**CHARTER TOWNSHIP OF MERIDIAN
ENVIRONMENTAL COMMISSION
AGENDA
Wednesday, November 2, 2016**

October 24, 2016
Project No. G150126W10

Re: Wetland Use Permit No. 16-05 Application Review
Mayberry Homes, Silverstone Estates

JULY 20, 2016 SHEET 3 OF 7

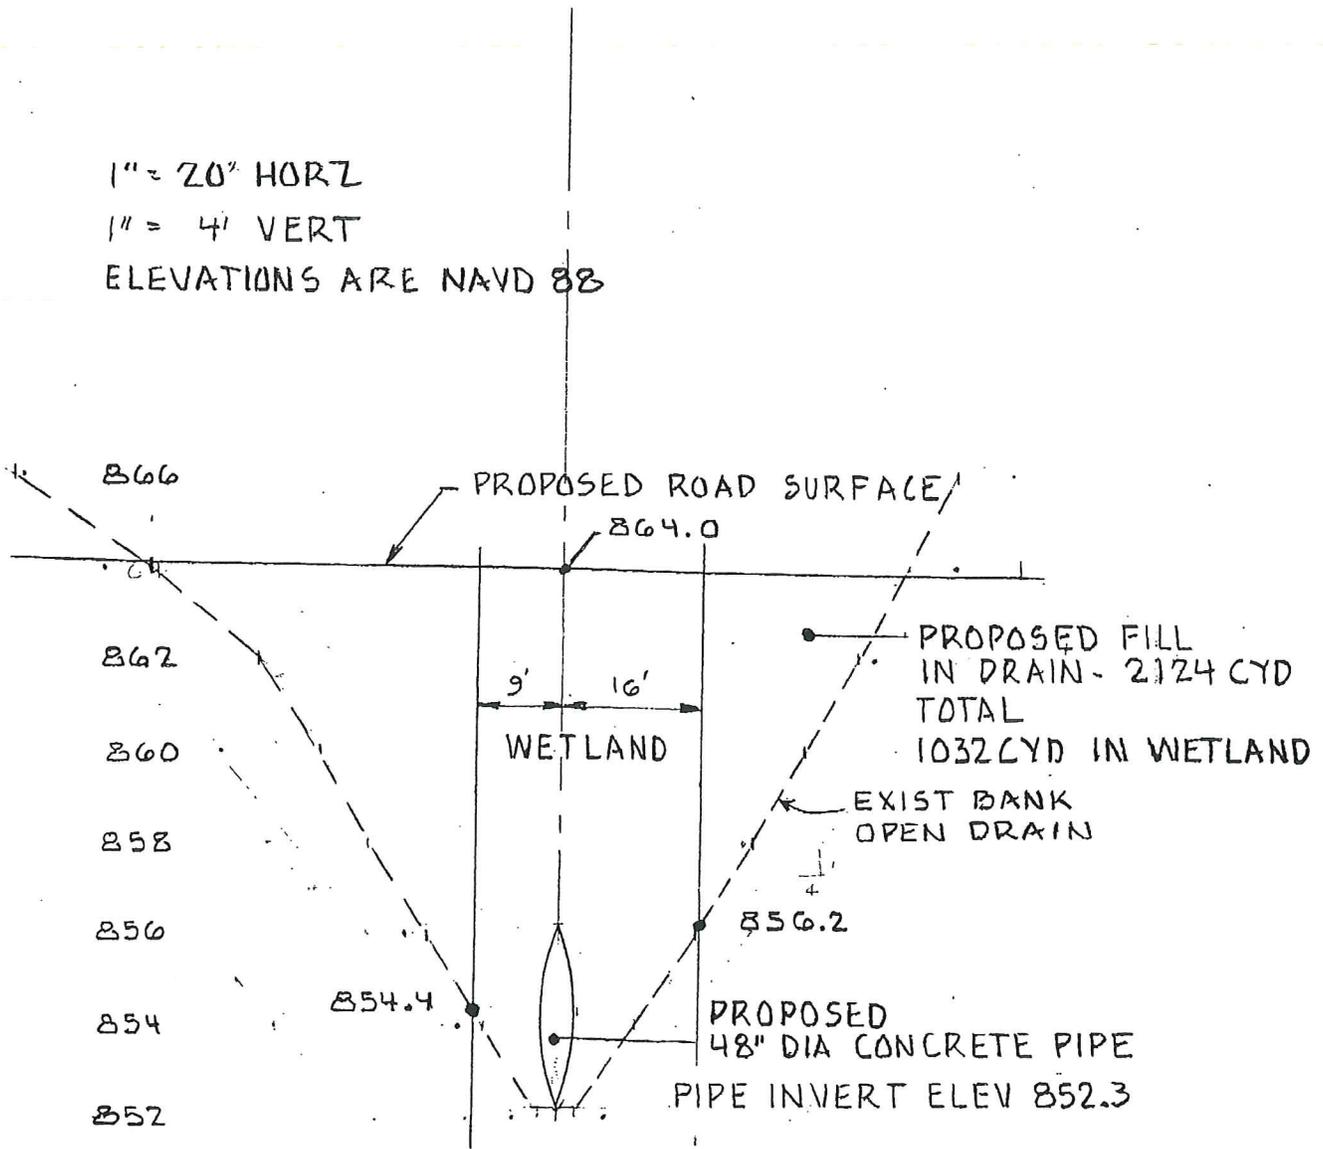
- Place one cubic yard of riprap at the downgradient end of the new culvert, within Wetland B. This wetland fill is noted on Sheet 3 of 7, but is not noted in Section 10A (Projects Requiring Fill) and Section 10C (Projects Requiring Riprap) in the JPA.

- Section A of the JPA notes the maximum width of fill within regulated wetland is 25 feet. Sheet 3 of 7 indicates the width of fill within wetland varies from approximately 21 to 32 feet. It is FTCH's opinion that the average width of fill is approximately 25 feet.

- The WUP Application states the area of wetland impact is 0.04 acre. However, the submitted plans indicate wetland impact of 0.11 acre: $192 \text{ feet (length of fill)} \times 25 \text{ feet (average width of wetland impact)} / 43,560 \text{ square feet per acre} = 0.11 \text{ acre}$.

- Submit a wetland mitigation and monitoring plan for Township approval. The wetland mitigation area must equal or exceed 0.165 acre of emergent wetland. The mitigation plan shall include:
